# WARRANTY BULLETIN SAFETY CAMPAIGN

Can-Am® On-Road Spyder™

Campaign no.: 2022-0019

February 9, 2023 Subject: **Rearview Mirror Lenses May Dislodge - Decreased Visibility** No. **2022-19**

**MIRROR HOUSING ASSEMBLY REPLACEMENT**

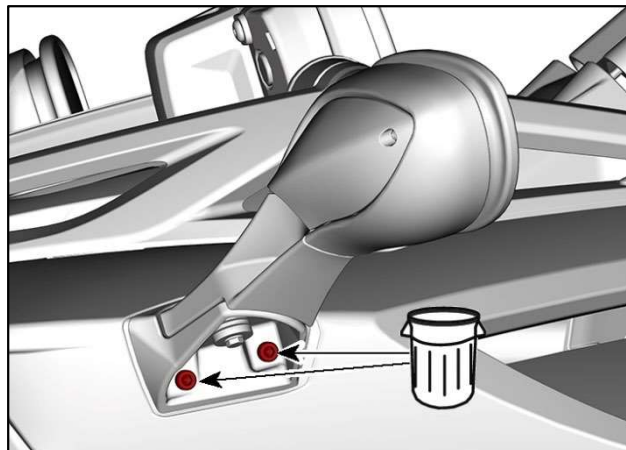
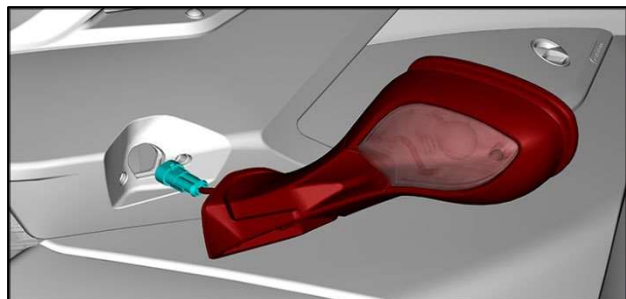
1. Remove and discard the two housing retaining screws.

2. Gently pull the mirror housing and disconnect the mirror light harness connector.

TIGHTENING TORQUE	
Mirror Housing Retaining Screw	3.5 N•m ± 0.5 N•m (31 lbf•in ± 4 lbf•in)
